REVISED LETTER OF UNDERSTANDING & STAFF RECOMMENDATION

RE: **DRI 2590 Peachtree Dunwoody Pavilion**

REGIONAL REVIEW FINDING

ARC REVIEW CODE: R1606171

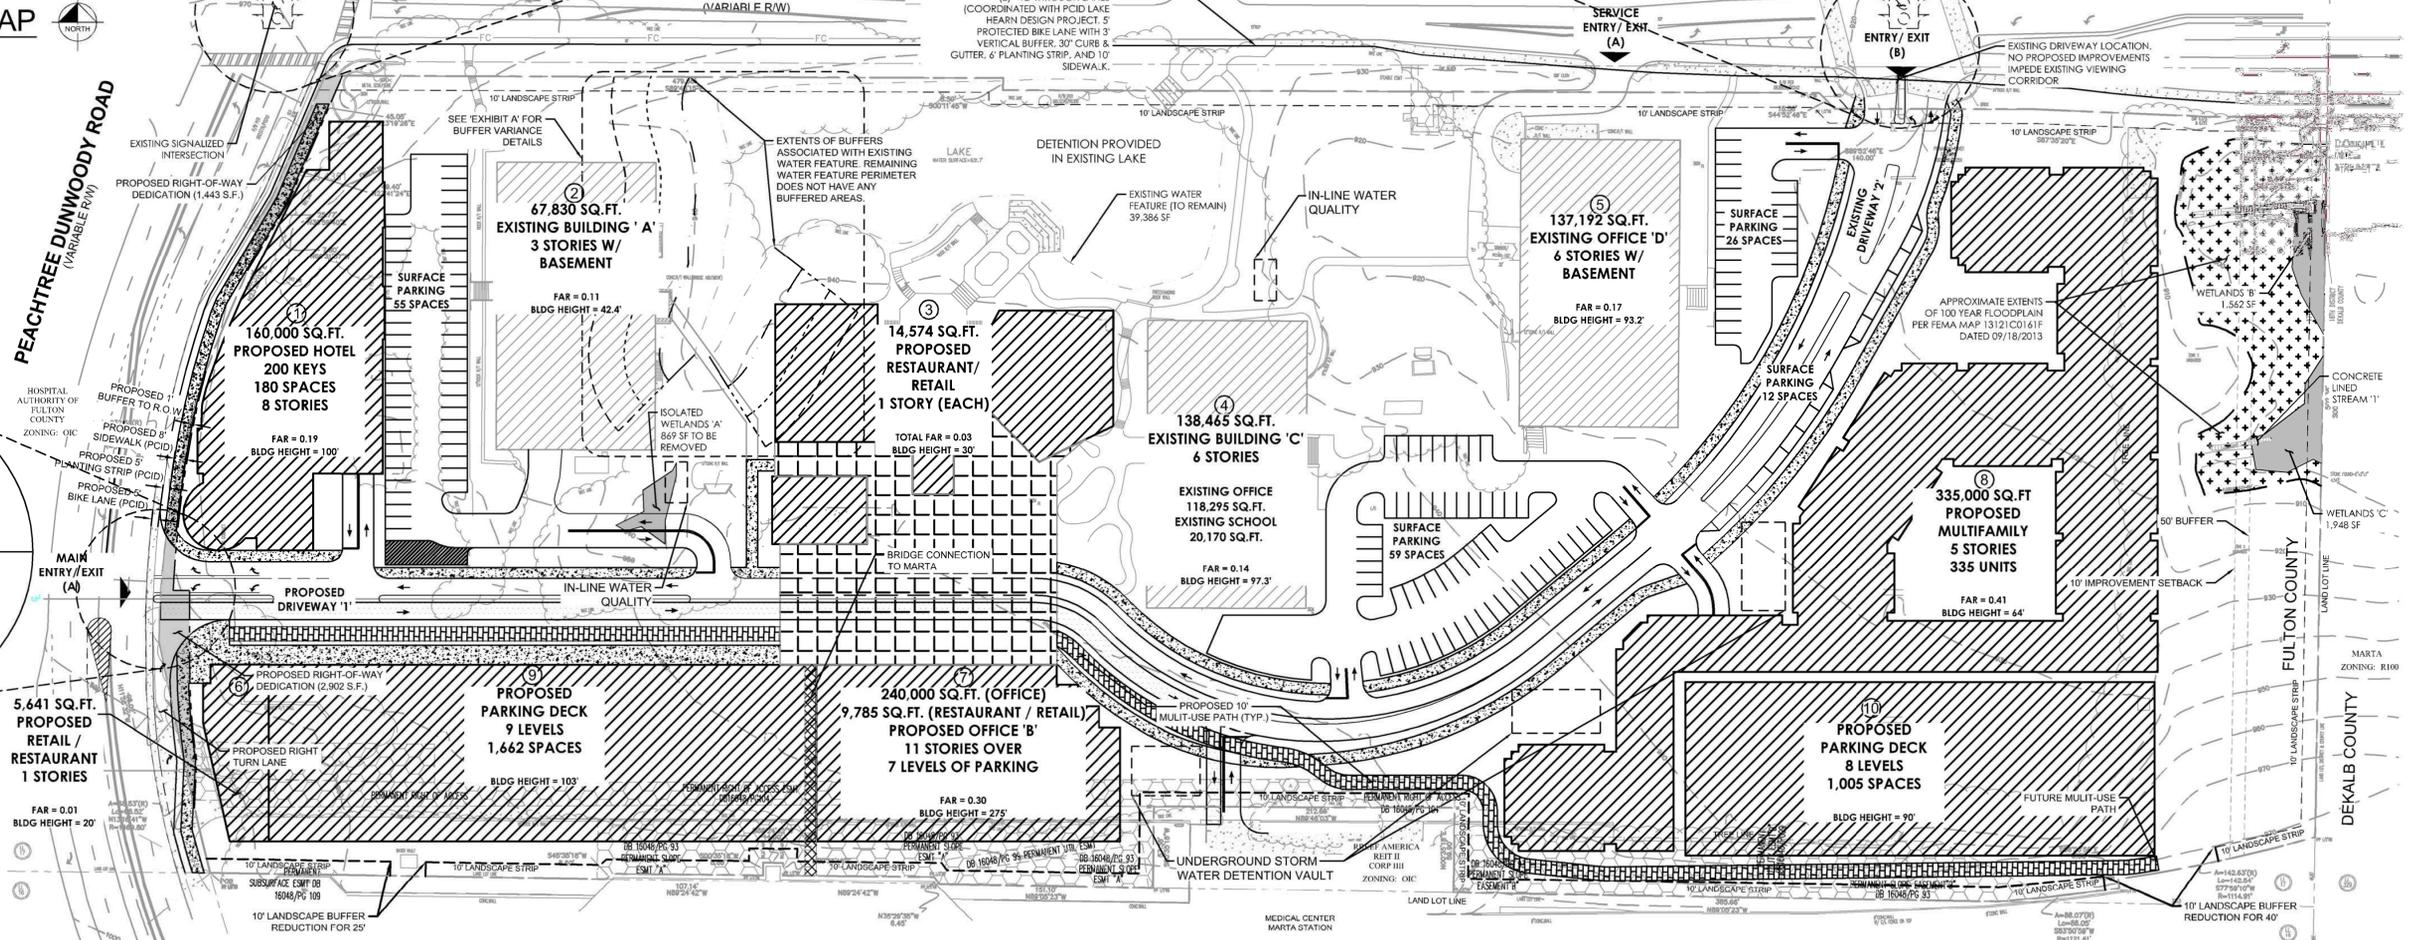
Provide a pedestrian connection from the site to the Medical Center MARTA station, as approved by MARTA.

Coordinate with GRTA Xpress and MARTA on the required turning radii of the southeastern corner and the stop bar locations at the Lake Hearn and Peachtree Dunwoody Road intersection to accommodate for commuter coach and/or local bus future northbound right turn movements.

Along these lines, the connection between this DRI and the Medical Center MARTA station should be constructed as planned. This connection should link both sides of the station for MARTA riders and non-riders alike, thereby enhancing area-wide walkability. Care should also be taken to ensure that the development promotes a functional, safe, clearly marked and comfortable pedestrian experience on all streets, paths and parking areas, as well as all connections from the project to neighboring uses. The development team is also encouraged to ensure that end-of-trip facilities (bicycle racks, etc.) are provided for residents, workers and visitors at key locations throughout the site.

ARC recognizes that vehicle parking totals are not finalized. The current plan proposes a total of 2,999 parking spaces, which is more than is required by code. In keeping with the goals of ARC's LCI program and the growing emphasis on transit use and pedestrian connectivity in the Perimeter area, the developer and City should explore reducing the amount of parking on site. This effort could reinforce and encourage the use of alternative transportation modes, especially transit, given its direct connection to this DRI.
